Subject ▶ Change on Ball Bearing

For Models ▶ 6820V,6402,6402-KDA,6402X-KDA,6302-KDA and 6303-KDA

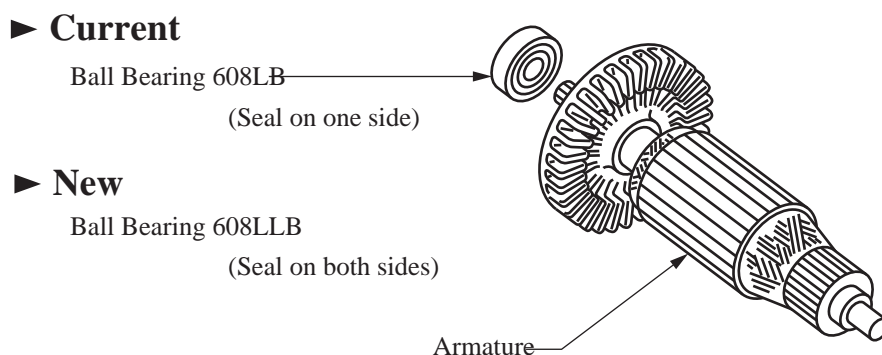
Description ▶ As in the following figure

Item No.	Current part		Q'ty	I/C	New part		Q'ty	Note
29	Ball Bearing 608LB 211033-2		1	<=	Ball Bearing 608LLB 211031-6		1	The current part can be used for 6510LVR,6805BV,etc.

Interchangeability mark:<= means that the new part can be substituted for the current.

6820V : From serial No.384586E
6402 : From serial No.41246E
6402-KDA : From Jan.,1996
6402X-KDA : From Jan.,1996
6403-KDA : From Jan.,1996
6302-KDA : From Jan.,1996
6303-KDA : From Jan.,1996
